PARTS & SERVICES		Technical Service Bulletin (TSB) Global Telematics Box (TBM) Firmware Over The Air (FOTA) Update To SW 4.39			
REFERENCE:	TSB: 08-265-26 GROUP: 08 - Electrical	Date:	July 3, 2026	REVISION:	—
VEHICLES AFFECTED:	2026 (WD) Dodge Durango This bulletin applies to vehicles built on or before July 20, 2026 (MDH 0720XX) equipped with Global Telematics Box Module (Sales Code RDG).			MARKET APPLICABILITY: ☒ NA☐ MEA ☐ SA☐ IAP ☐ EE☐ CH NOTE: This bulletin applies to the North America market.	
CUSTOMER SYMPTOM:	Customers must experience a Malfunction Indicator Lamp (MIL) illumination and one or more of the following Diagnostic Trouble Codes (DTCs): • B22A9-96 - ECU Internal Performance-Component Internal Failure. • B1560-11 - Cellular Antenna 1-Circuit Short To Ground. • B1560-13 - Cellular Antenna 1-Circuit Open. • B1561-11 - Cellular Antenna 2-Circuit Short To Ground. • B1561-13 - Cellular Antenna 2-Circuit Open. • B1562-14 - GPS Antenna-Circuit Short To Ground Or Open. Customers may also experience the following: • "UConnect Box Requires Service" Message in Radio Display.

Fig. 1

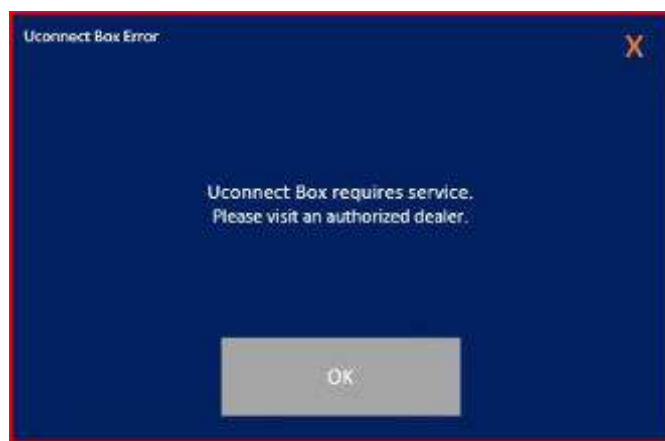
Message display on the radio screen "Uconnect Box requires service. Please visit an authorized dealer." [Fig. 1.](#)

This bulletin provides information regarding the latest Firmware Over The Air (FOTA) update and provides the service technician an overview of the steps a customer will need to take to complete the update. The TBM software will be updated from 4.38 to 4.39 (243187 SW PN number).

Fig. 2

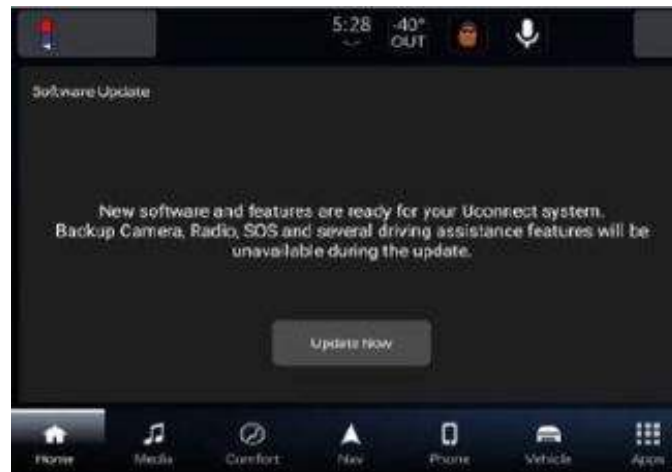
1. The vehicle needs to be in 'Park'. The ignition needs to be in the off position.
2. If the customer selects “Update Now” [Fig. 2](#), they can shut off the vehicle and leave. The update will be completed automatically.

Fig. 3

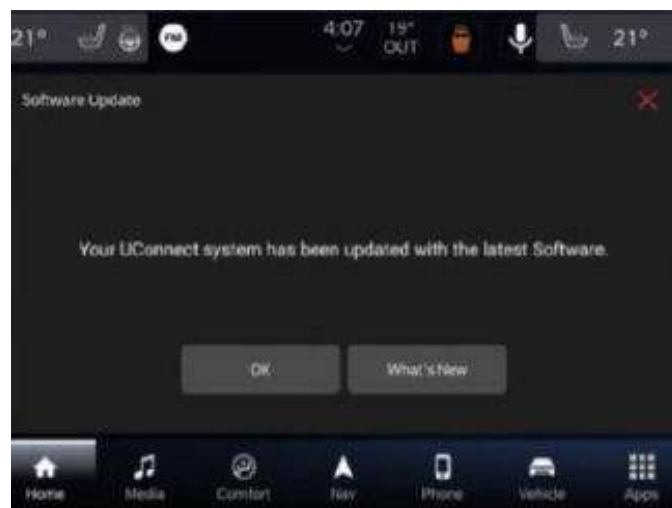
3. Upon completion of update, the radio will display a confirmation message [Fig. 3](#).
